**A REVIEW OF THE HYDROGEOLOGY ELEMENT OF THE
DRUMDERG WIND FARM ENVIRONMENTAL STATEMENT**

October 2004

Derek Ball

The proposal is for the construction of 16 turbines on Drumderg (NO 178 550), near Bridge of Cally.

Figure 1: Location of Drumderg

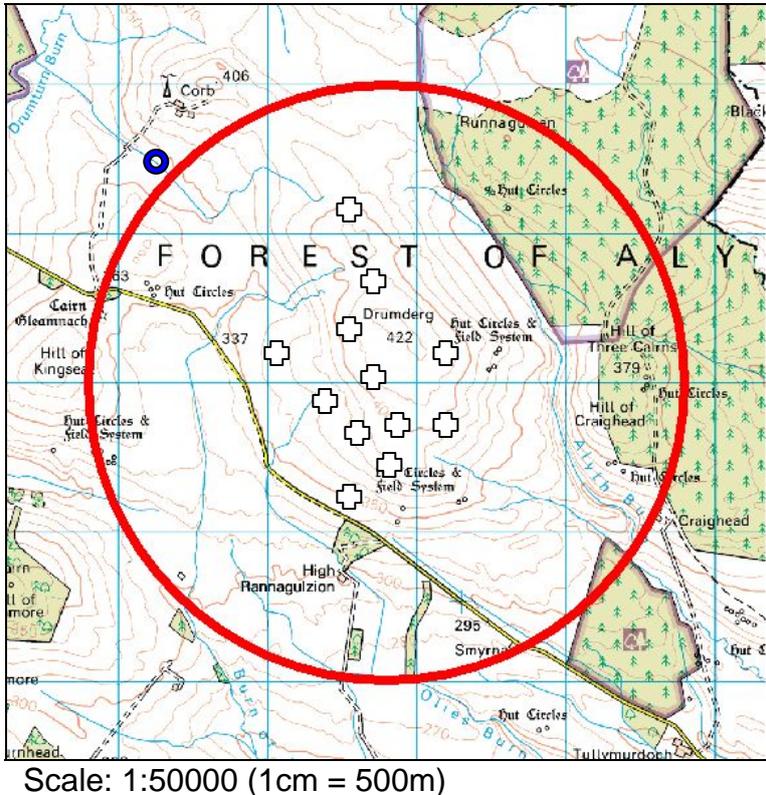
Private water supplies: 12.34 mentions the Corb spring (Figure 1) as the only private groundwater supply identified. The well is described as a collection sump from a spring located further up on the hillside, although no exact location is given for the true source of water, the spring.

BGS concludes that the actual location of the water piped to the well needs to be investigated before a decision can be made on risk. Turbines 12, 13 and 14 are the closest to the source and, although are unlikely to affect it, the location should be determined, in spite of the low risk. The effects of the operational phase on groundwater is expected to be insignificant.
